## Report to the Future Melbourne Committee

### Application to Amend a Planning Permit: TP-2019-80/B 19-21 and 23-29 Bourke Street, Melbourne

15 August 2023

**DELEGATE REPORT**  
**APPLICATION TO AMEND A PLANNING PERMIT**

SHOPFRONT GLAZING PANEL  
INSET MINIMUM 200mm FROM  
ADJACENT PLINTH

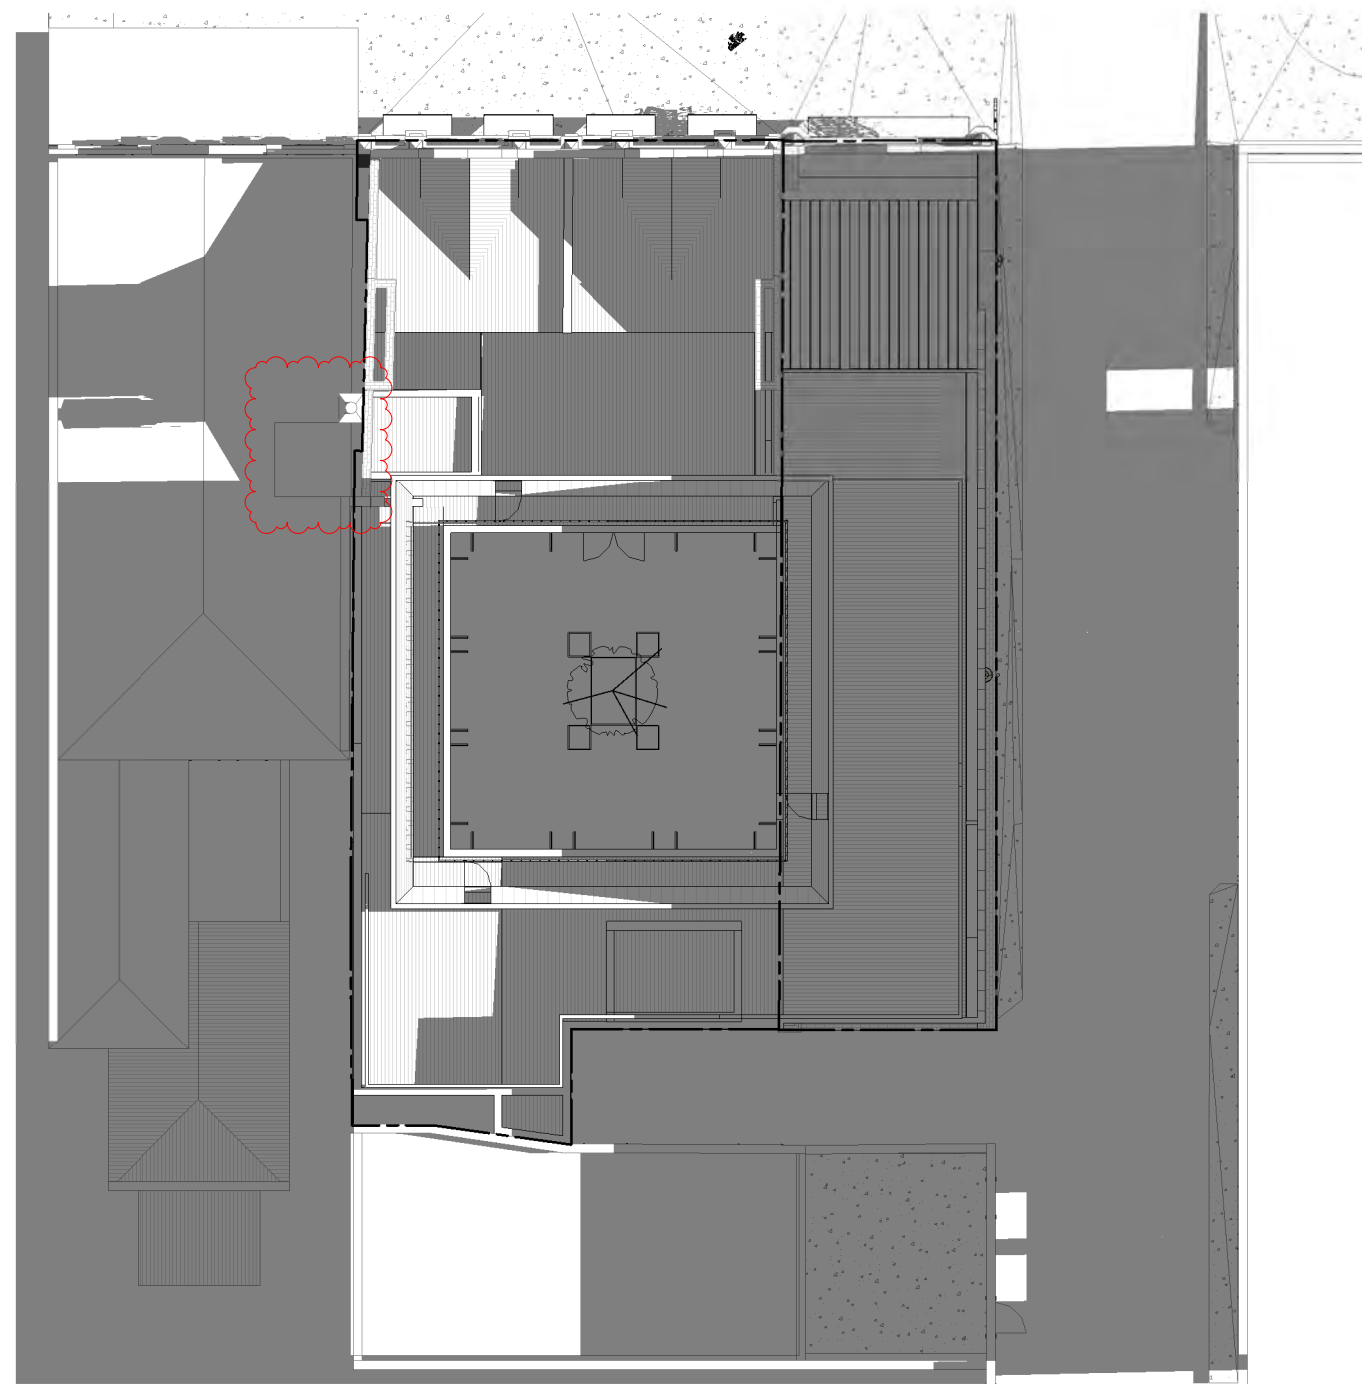
- A 200 mm rebate in the shopfront of 19-21 Bourke Street at the location of the former entry.
- Remove the paint from the side (east) elevation and first floor front façade of 19-21 Bourke Street.
- Reconstruct the rear (south) wall of 19-21 Bourke Street, including the chimney, using the original bricks. It is noted that there is a discrepancy between the proposed rear elevation and roof plan; condition 1 amended plans are recommended on any amended permit that may issue to include the reconstructed chimney on the proposed roof plan.
- Retain and repair all upper level windows on the front facades of 19-21 and 23-29 Bourke Street and the side elevation of 19-21 Bourke Street (no permit required but notation included for information purposes).
- The chimney and light well to 31-33 Bourke Street.

- Basement footprint extended to the rear boundary for the entire width (an additional 1.1 m x 5.7 m).
- Modifications to the internal layout, including an enlarged bin room in the basement and a single entry to Bourke Street. A 200 mm glazing recess will denote the entry to 19-21 Bourke Street that will be closed.

Figure 6: Proposed Demolition Elevations (source: Mills Gorman Architects)

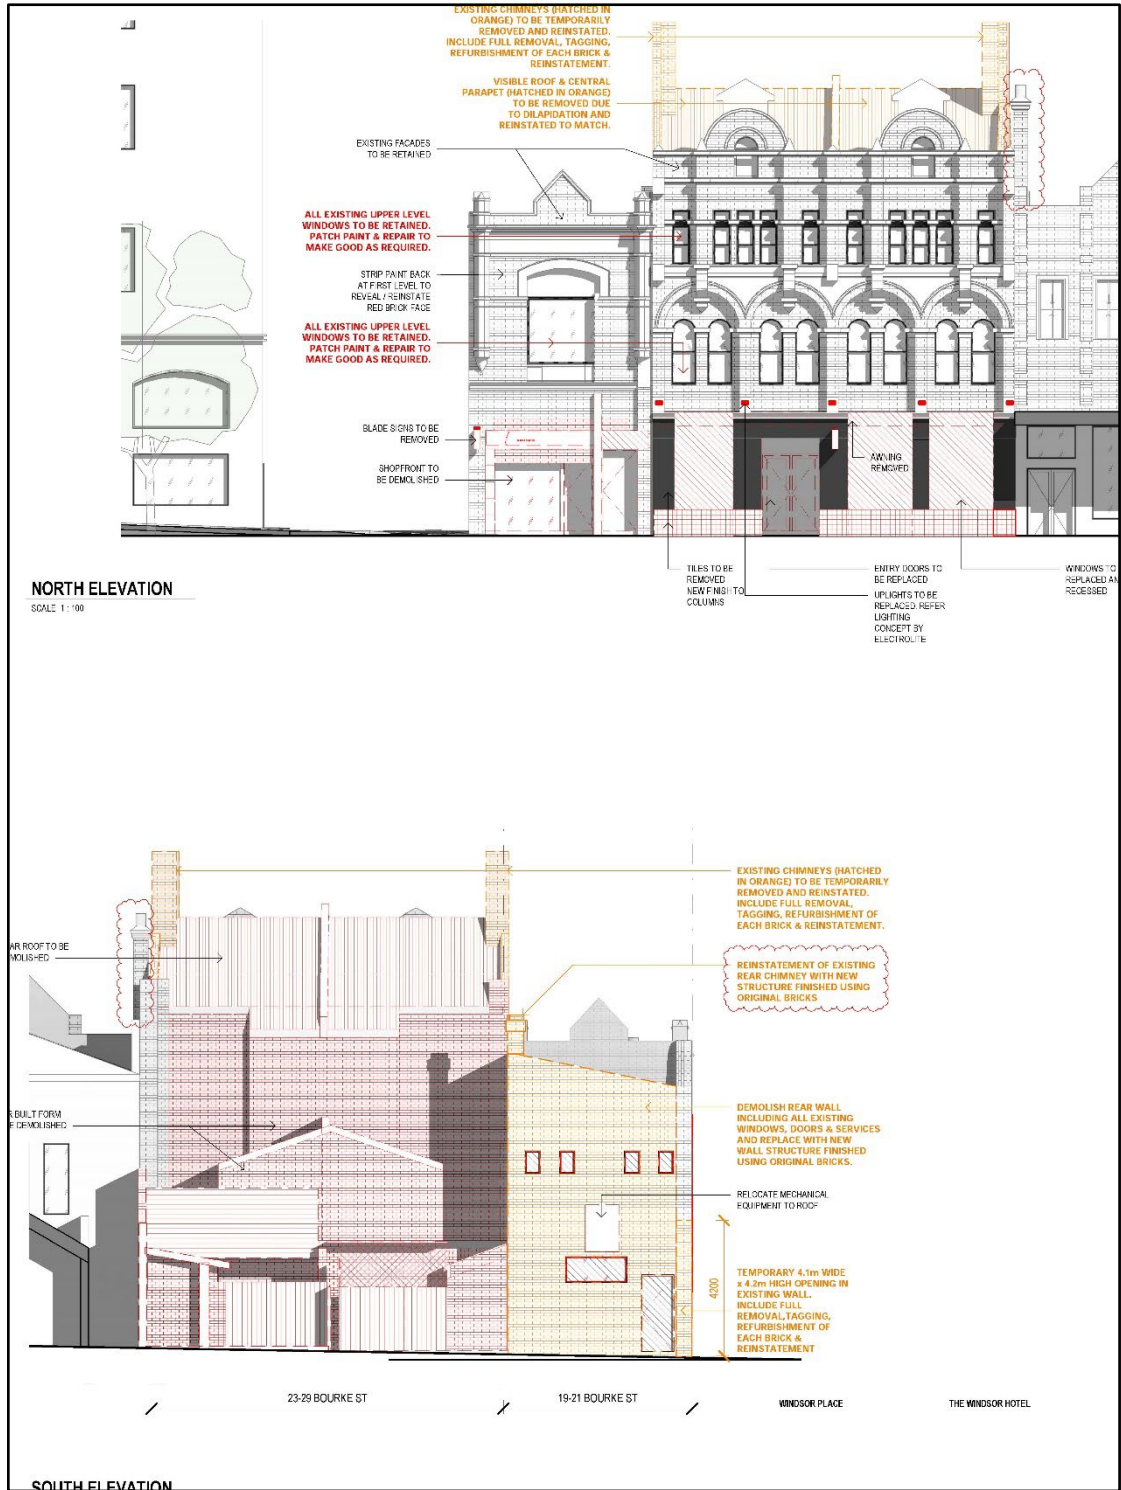
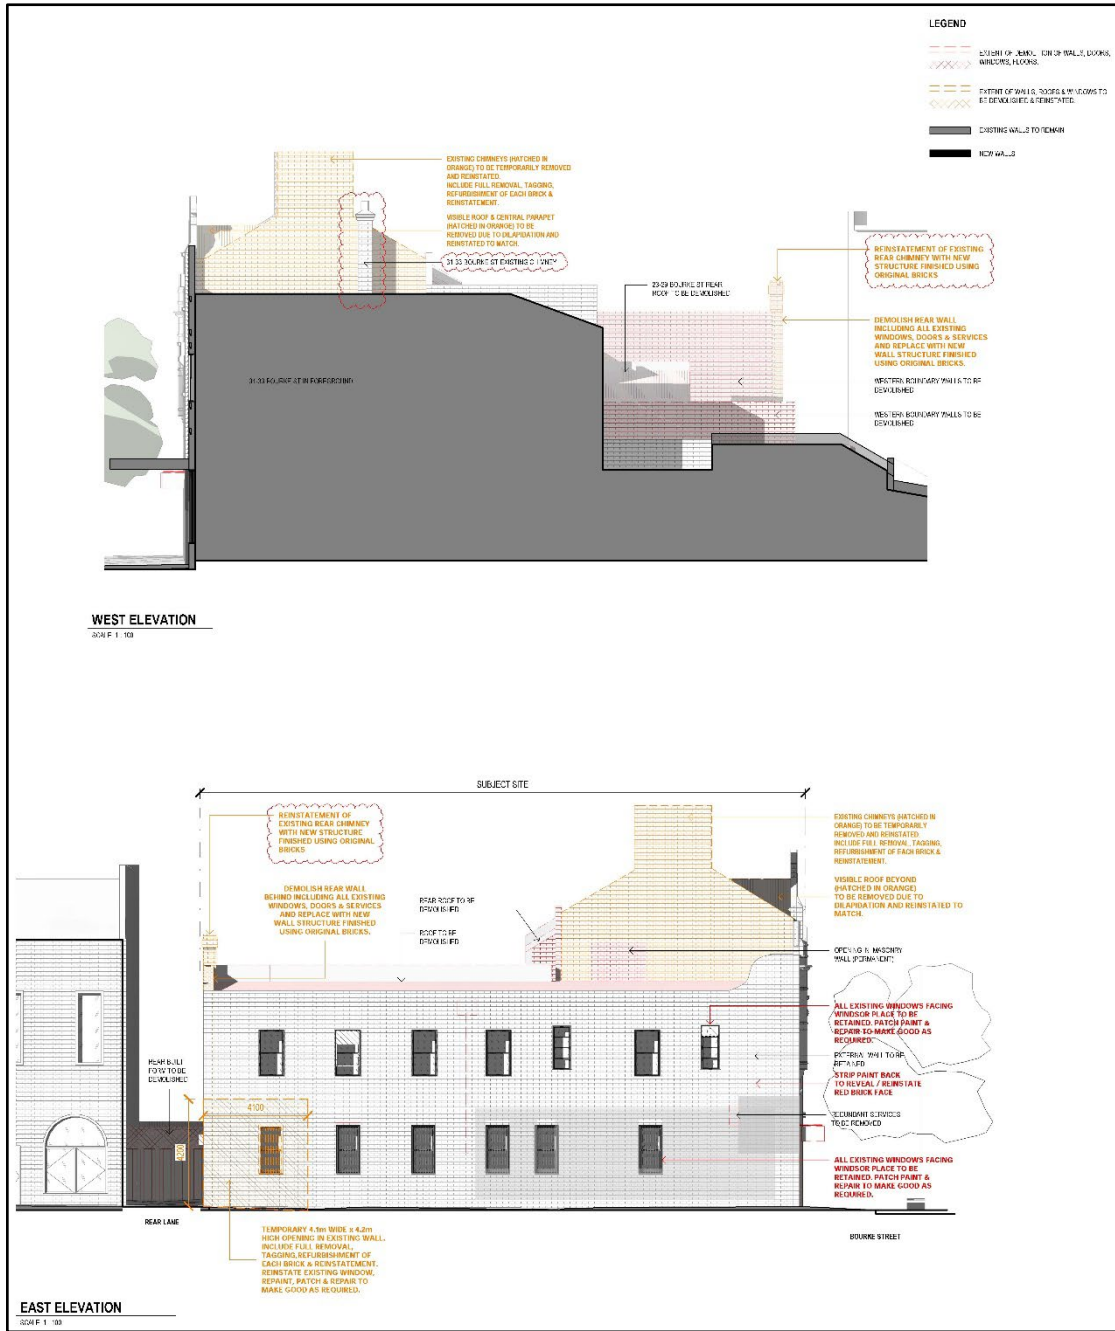
The partial demolition shown in orange on the demolition plans (See Figures 6 and 7) does not involve disposal of original heritage fabric but deconstruction and reconstruction. This includes surveying and documenting the chimneys and boundary walls before they are carefully dismantled, as well as tagging, cleaning and storing the original heritage fabric so that it can be used in the reconstruction.

In addition, it is recommended that a number of permit conditions be amended and added to ensure an authentic, evidenced based reconstruction and restoration, in accordance with endorsed drawings and documents, to conserve the significance of the heritage place.
